STAFF RECOMMENDATION 1507 Sweetbriar Avenue May 21, 2014

Application: New construction-addition
District: Belmont-Hillsboro Neighborhood Conservation Zoning Overlay
Council District: 18
Map and Parcel Number: 11704011500
Applicant: Manuel Zeitlin, architect
Project Lead: Robin Zeigler, robin.zeigler@nashville.gov

Description of Project: The applicants propose a one and one-half story addition with two one-bay attached garages to an existing one and one-half story historic house for use as a duplex.

Figure 6: 1419 Holly, denied application

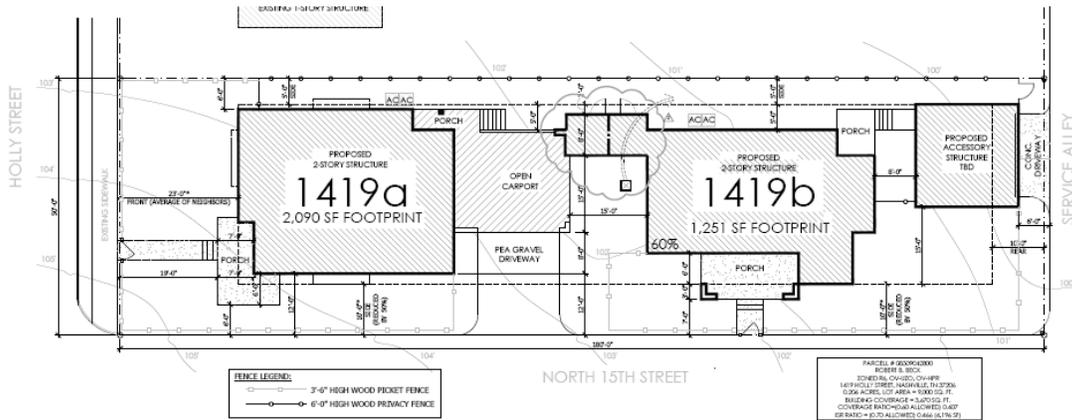
Another project, similar in configuration, was therefore denied at the corner of Holly and 14th.

Both of the previous projects were constructed on corner lots and the proposed project is on an interior lot. Recently a project was approved at 1820 Wildwood that is a second unit attached to a historic one and one-half story home.

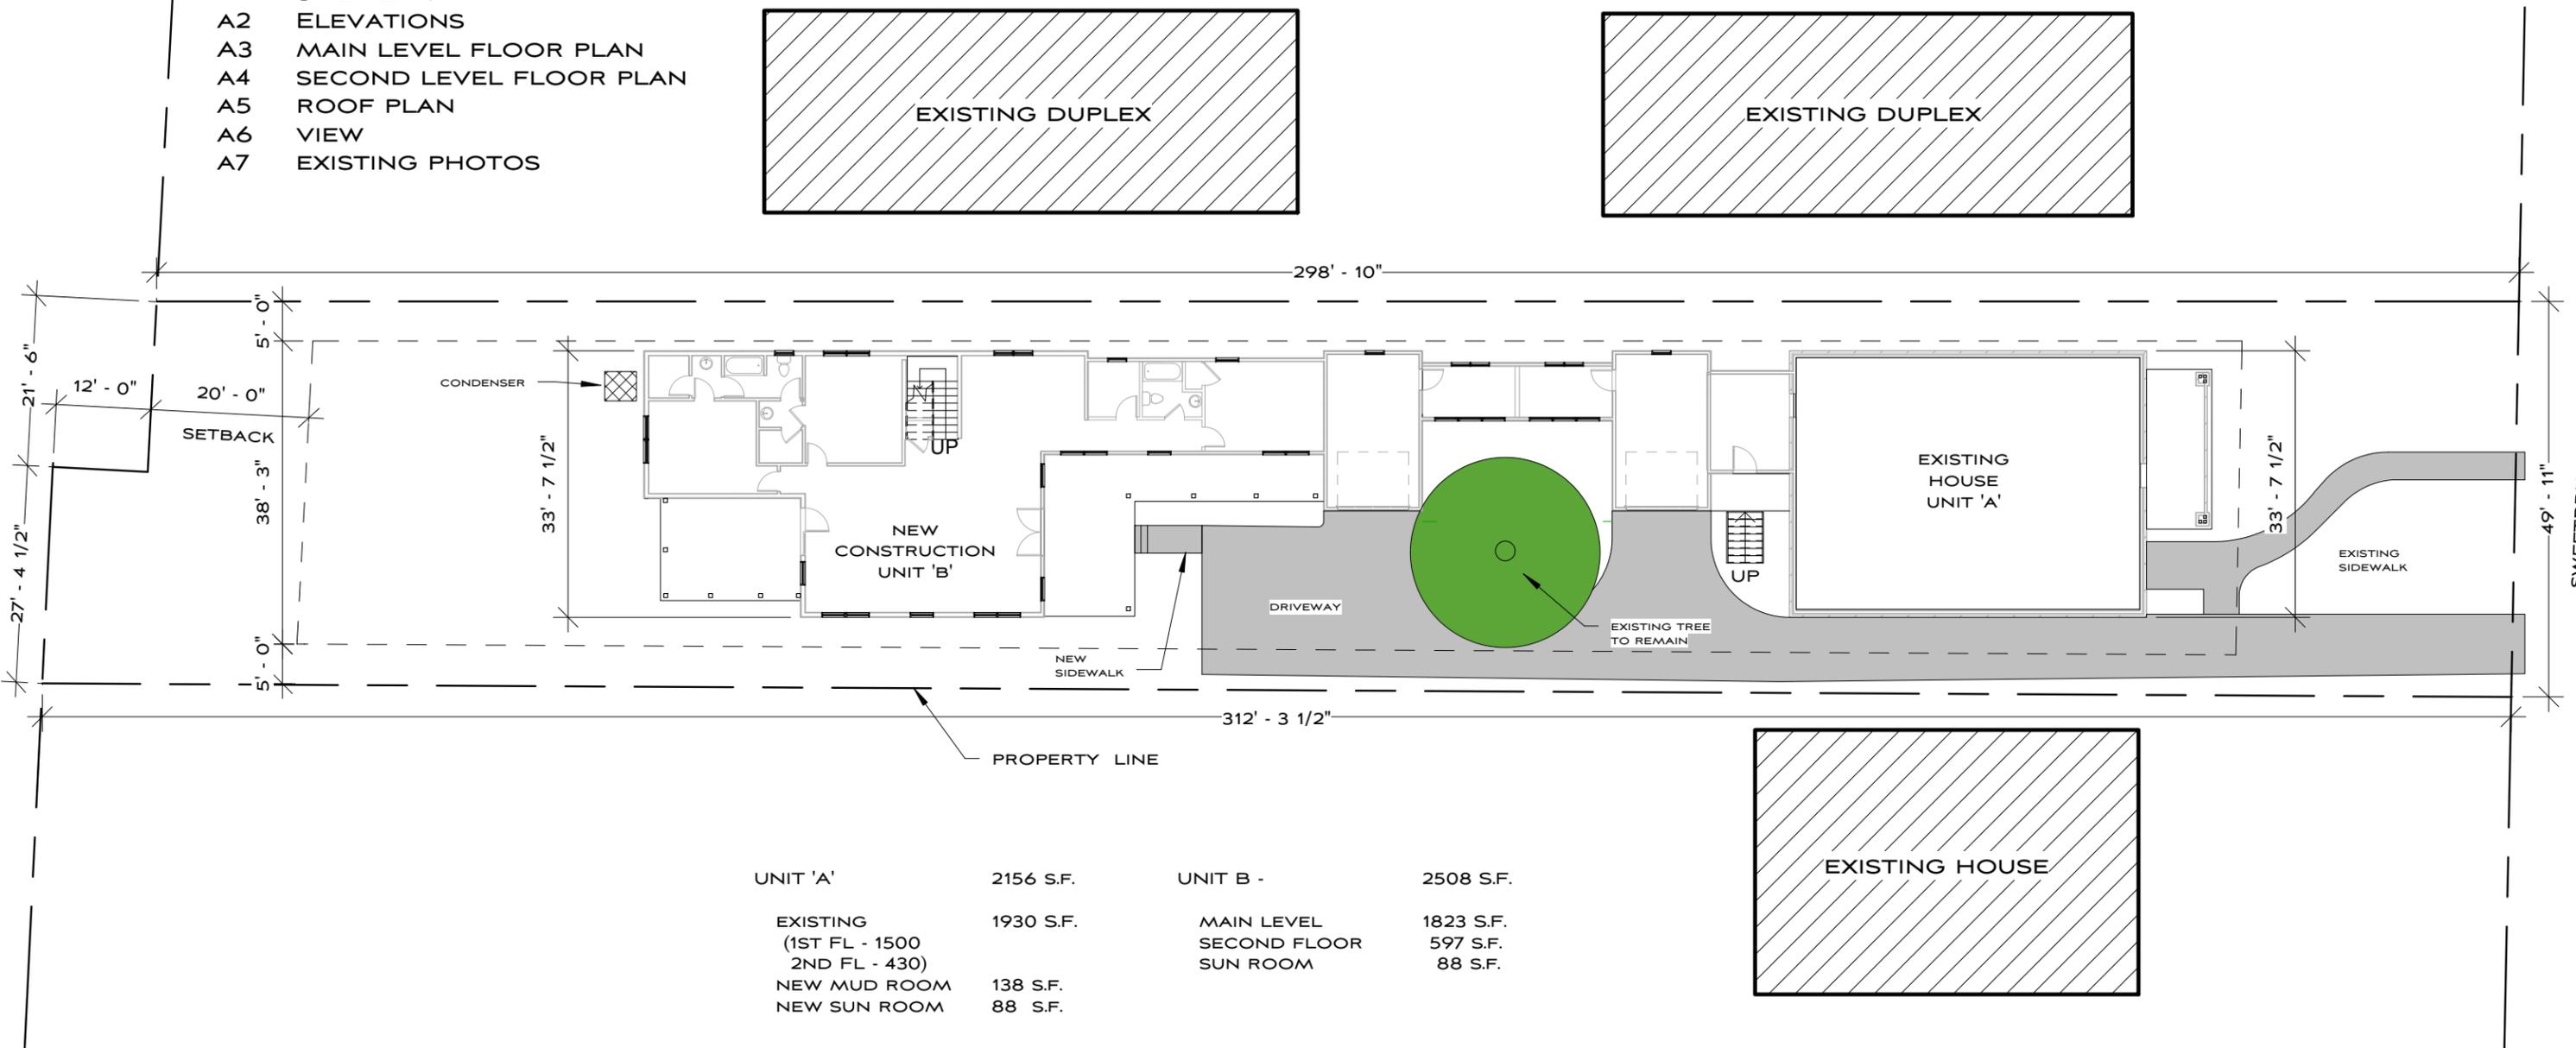
Outbuildings: The proposal includes two one-bay garages located between the two units. The Commission has a policy to only allow attached garages if they are at the basement level, as this is the only time that garages were attached historically. Staff recommends removing the garage bays and creating a detached outbuilding or parking pad.

- The massing and scale of the addition be reduced;
- The second unit be redesigned to be an appropriately scaled addition, rather than a second unit attached by a narrow connector;
- The attached garages be removed and either a parking pad or garage be added somewhere between the middle and the rear of the lot, as seen historically;
- Materials be approved by Staff;
- Both HVAC units be located at the rear of the building or on the sides of the building, mid-way back from the front wall.

ELEVATIONS

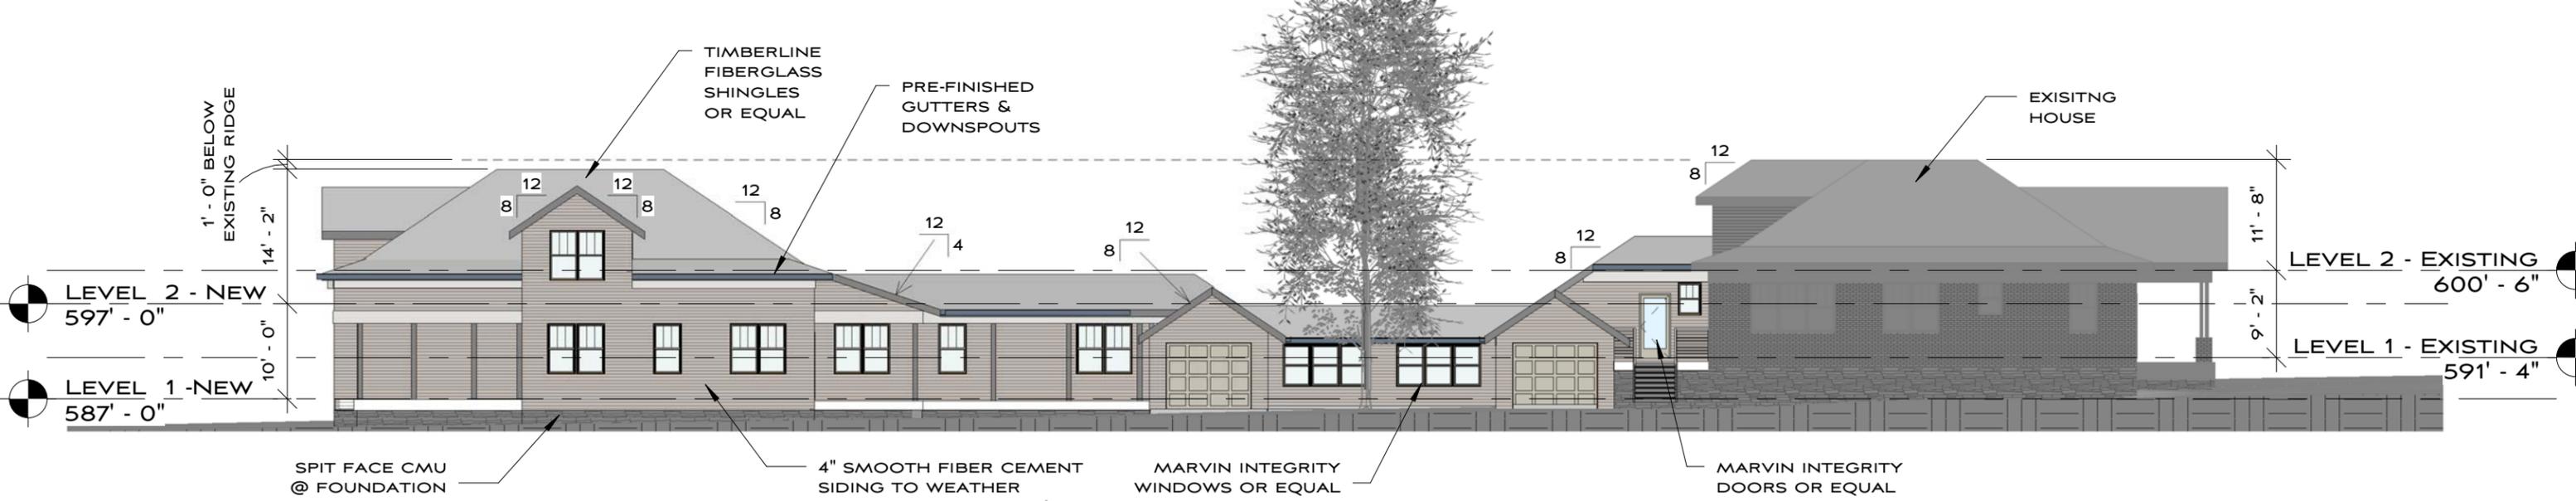
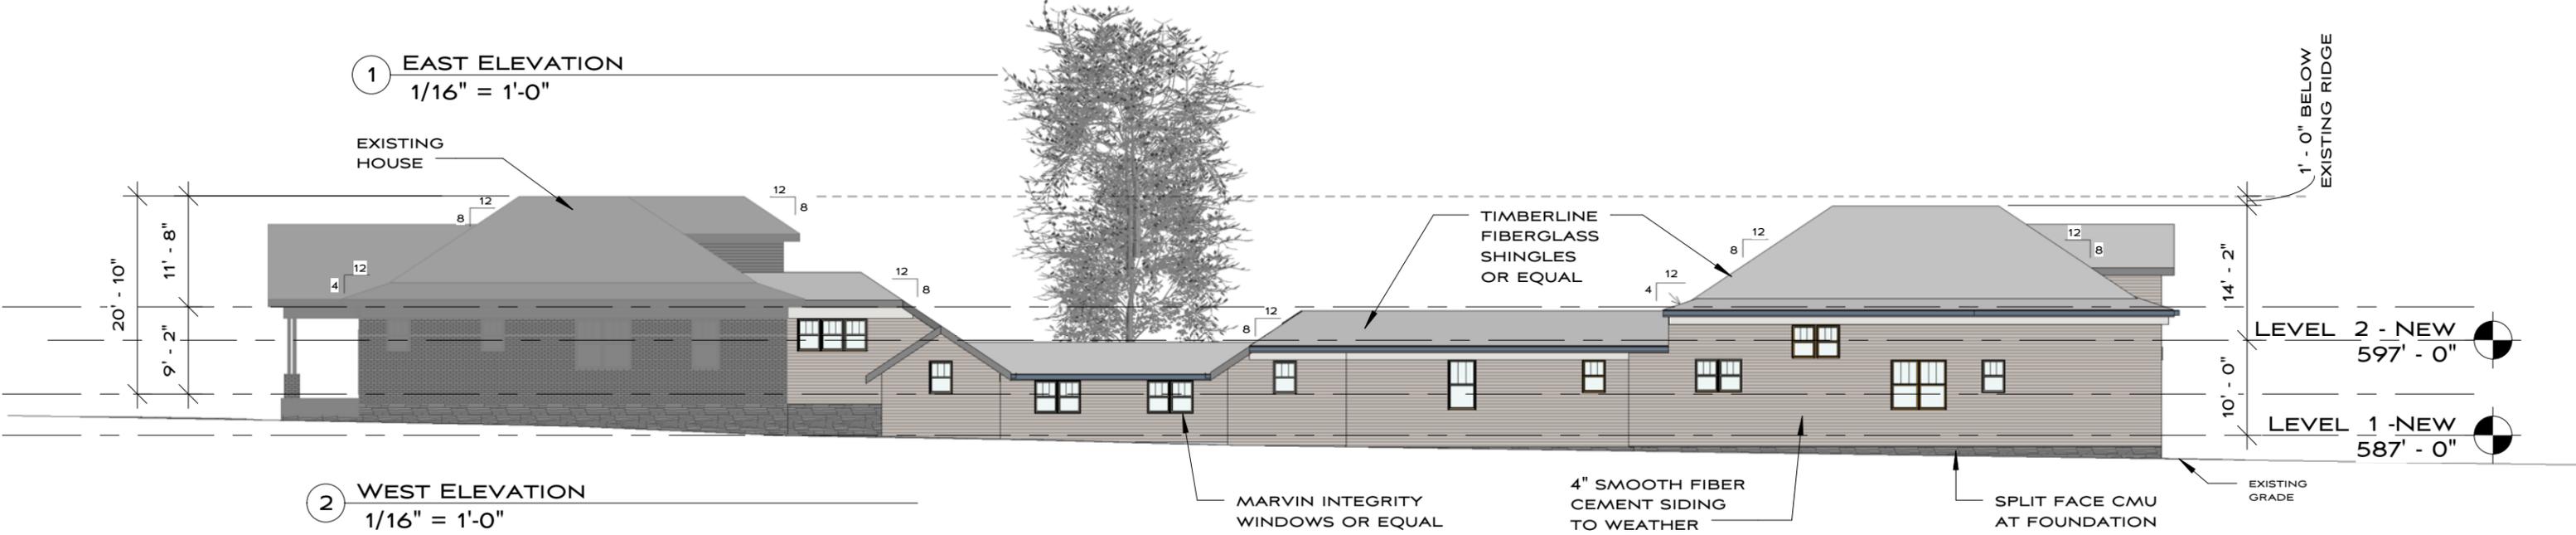
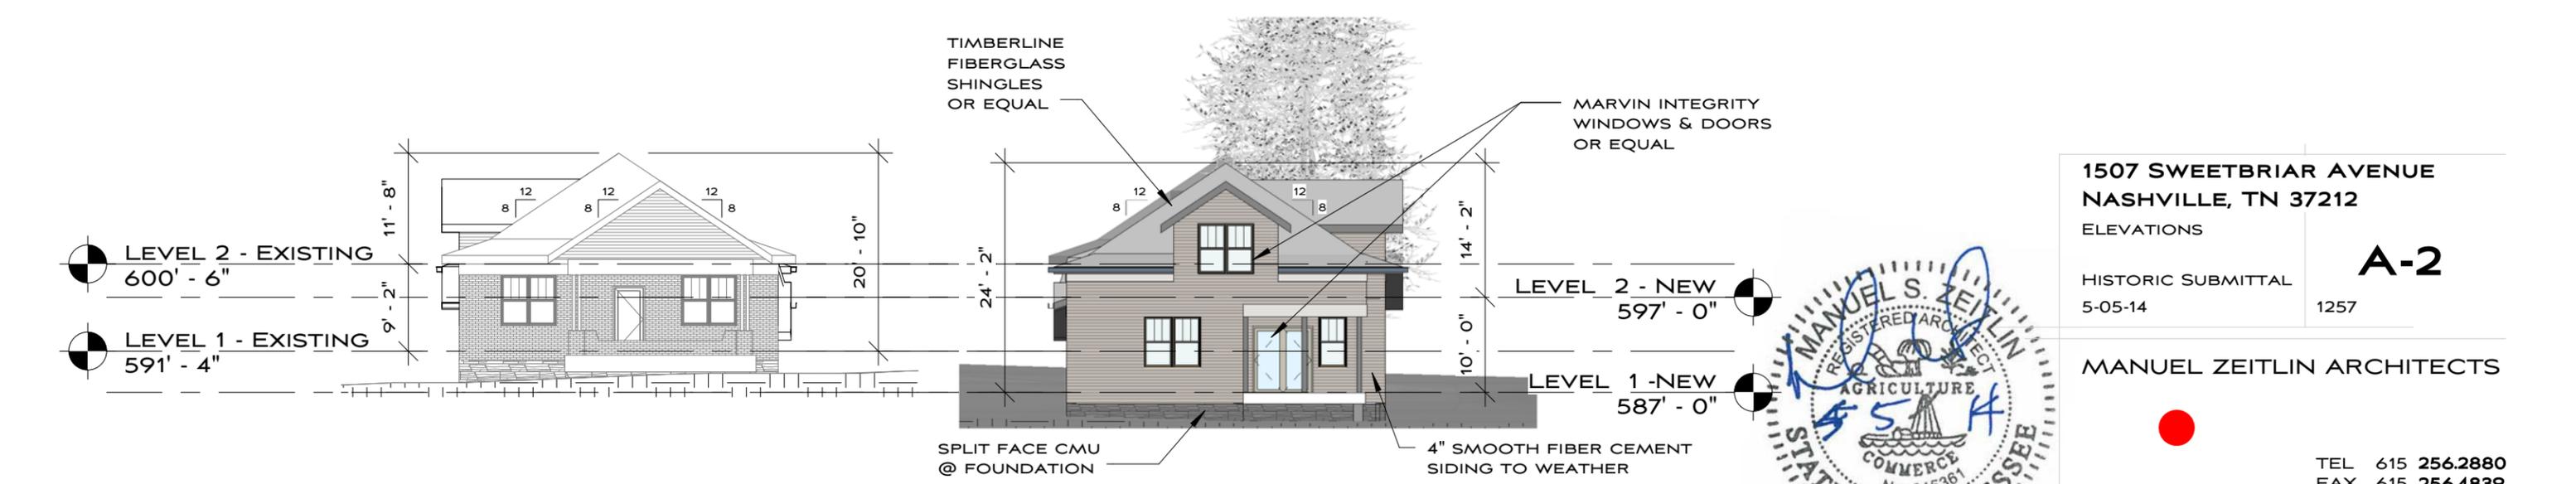
Height: The current building is a one and one-half story historic building that is approximately twenty-four feet (24') tall from finished grade. The addition will be approximately twenty-six feet (26') tall from finished grade but because of the change in grade will not appear to be taller than the existing house.

Roof form: The main portion of the addition will have a hipped roof with rear dormer similar to the existing house. Low gables connect these two ends with pitches of 8/12 and 4/12, all compatible with the neighborhood. Wall dormers are utilized towards the

Proportion and Rhythm of Openings: No changes to the window and door openings on the existing house were indicated on the plans. The windows on the proposed addition are all generally twice as tall as they are wide, thereby meeting the historic proportions of openings. The longest expanse of wall space without a window or door opening is approximately sixteen feet (16'); however, this happens far back on the addition.
